SLOPE STABILITY ASSESSMENT

**900 LAKESHORE ROAD WEST,
MISSISSAUGA, ONTARIO, L5H 1H9**

Project No. FG25-15006_V4

Revised March 19, 2026

Figure 10

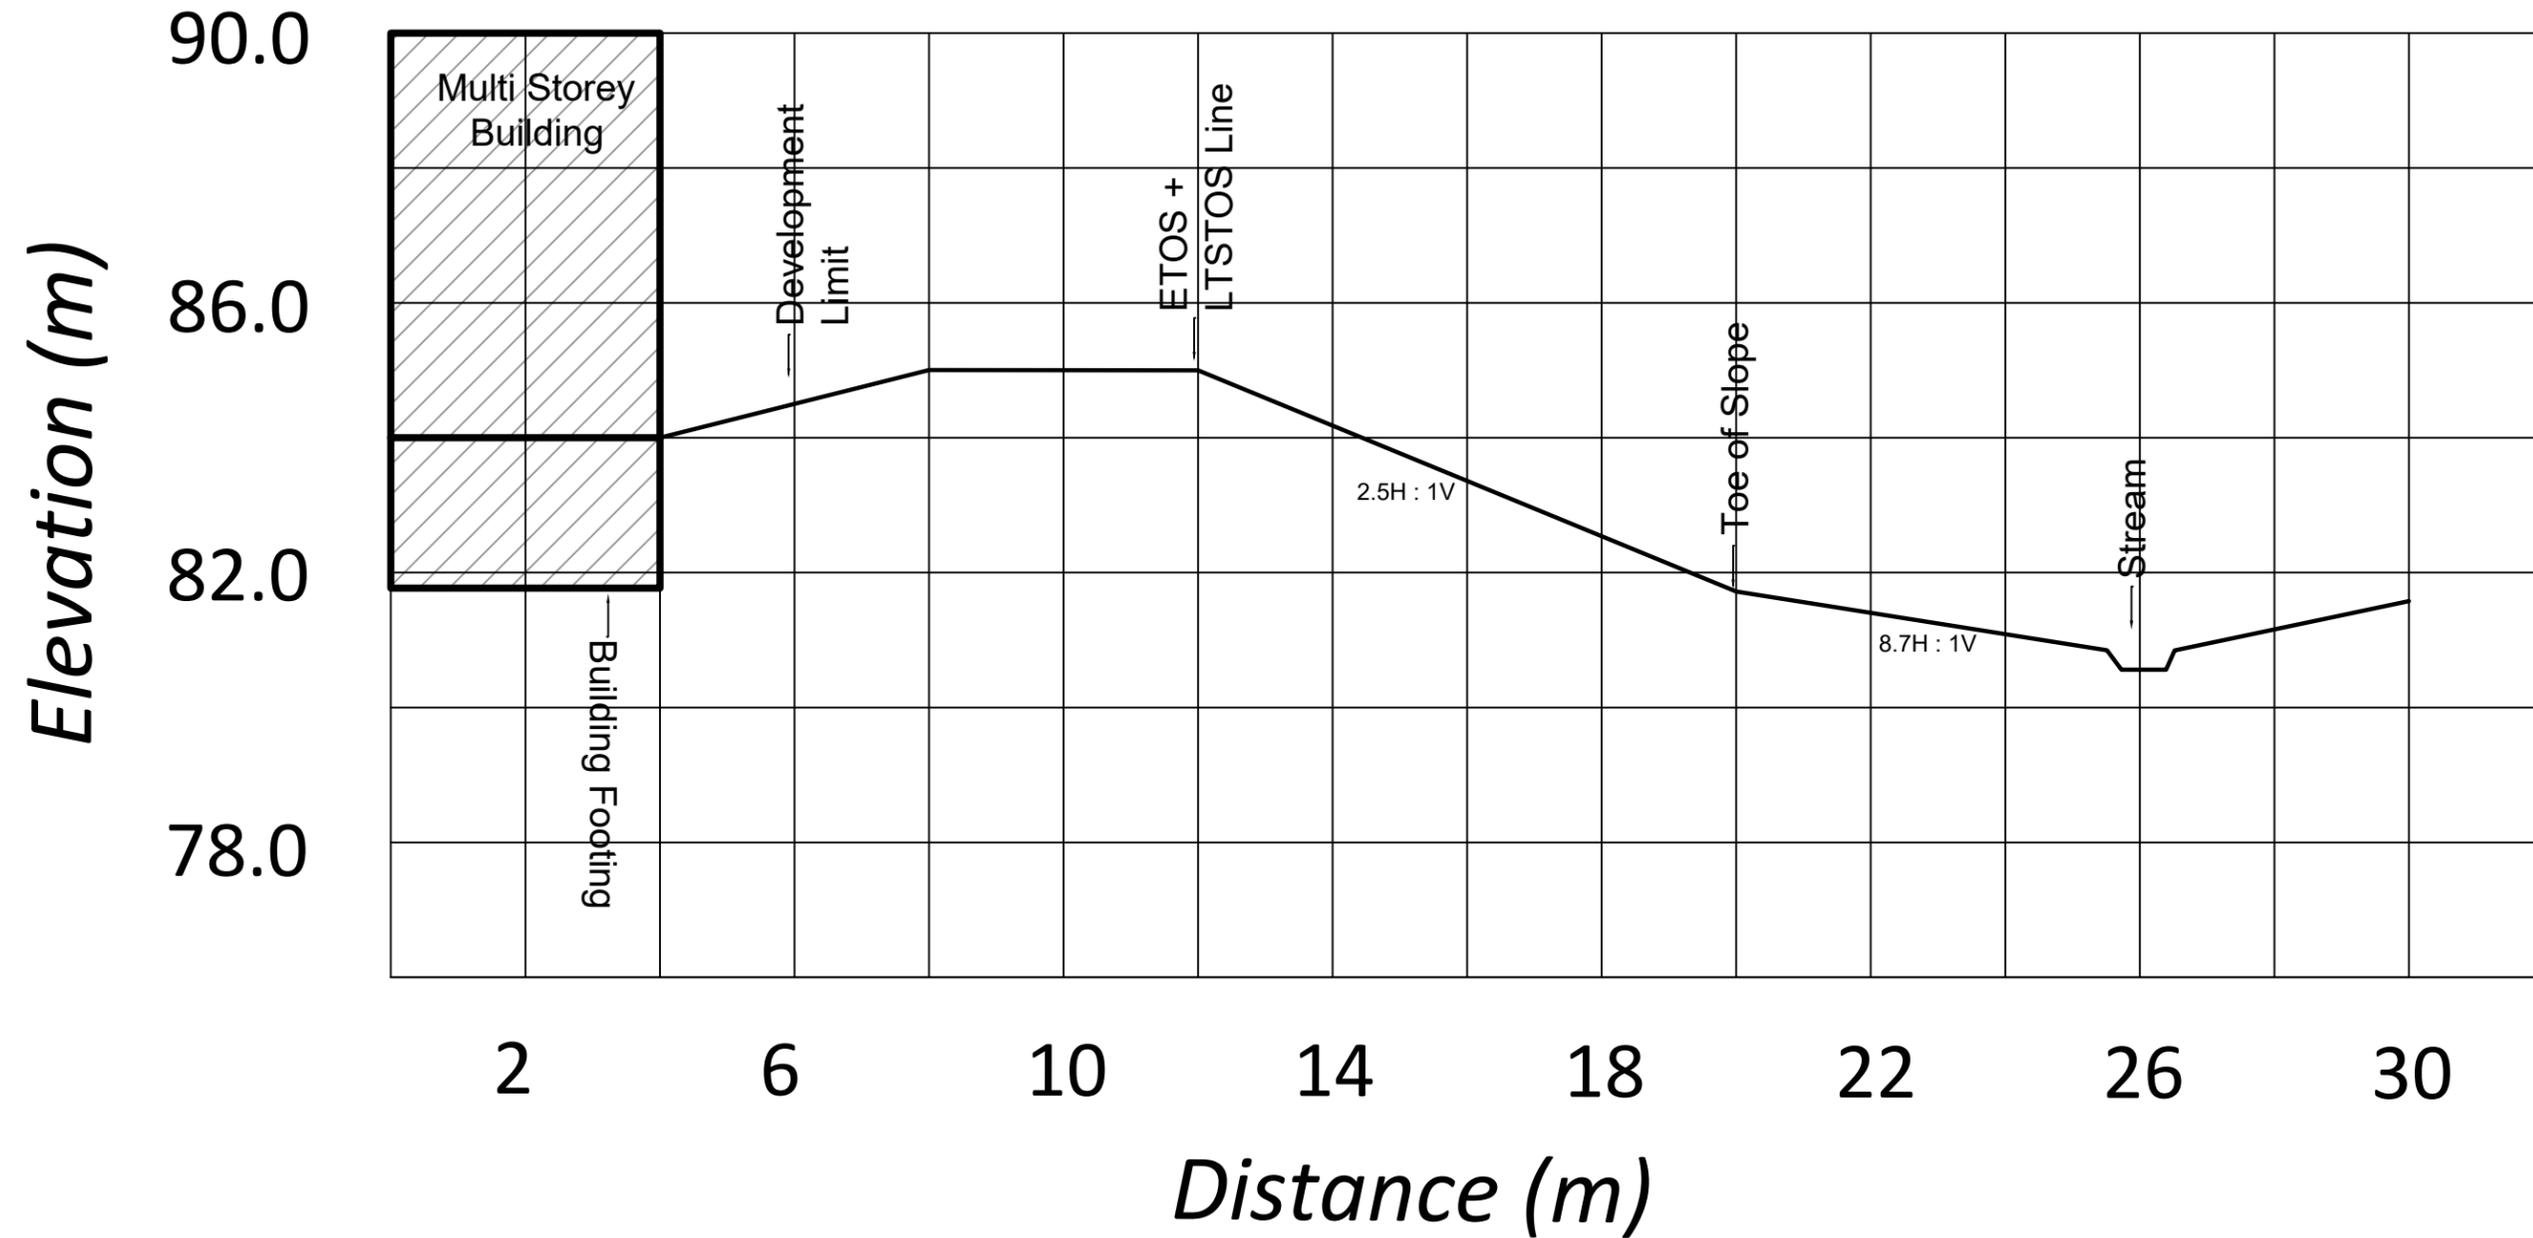
Engtec reviewed the site plan E3, the proposed redevelopment would have south edge at 7.7m from the ETOS+LTSTOS line (scenario is illustrated in Figure 10 & 12). The foundation would likely be established at about 3m below the existing grade.

Figure 11

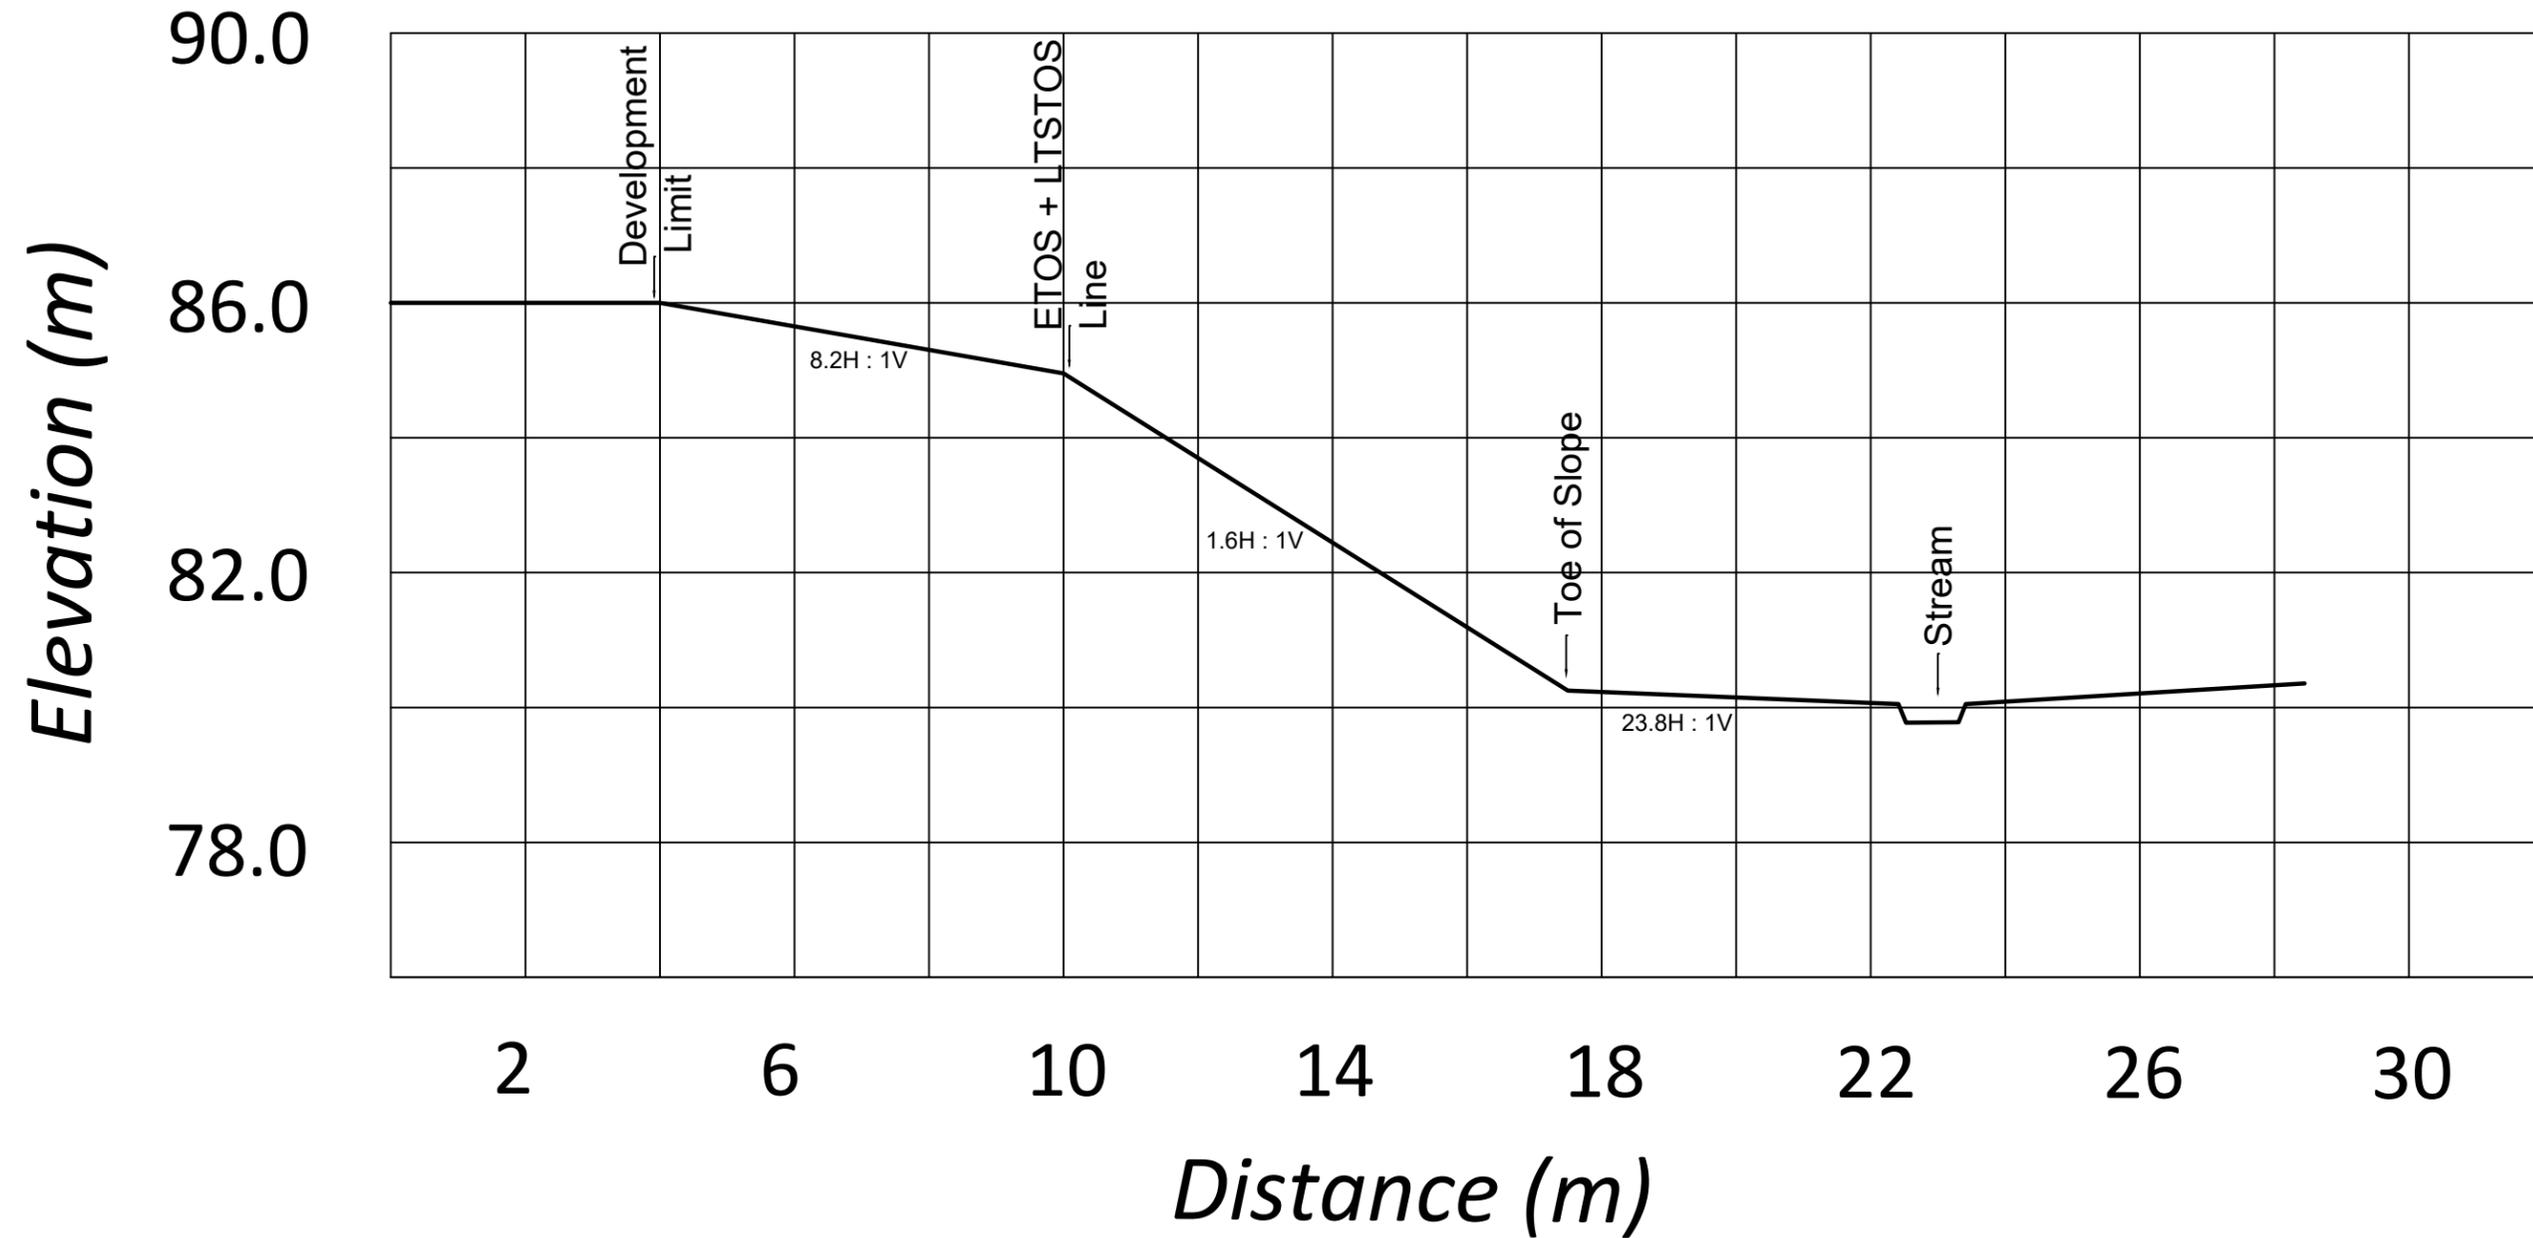
Section of Slope	Minimum FOS				Stability Component* (m)	Toe Erosion Allowance (m)	Access Allowance (m)	Total Setback
	Static	Figure	Seismic	Figure				
Section A-A'	1.713	3	1.367	4	5.70***	1	6.0	12.70
Section B-B'	3.496	5	2.562	6	0	1	6.0	7.0
Section C-C'	6.555	7	3.600	8	0	2.0	6.0	8.0
Section D-D'	**Figure 9				0	0	6.0	6.0
Section E-E'	**Figure 10				0	0	6.0	6.0
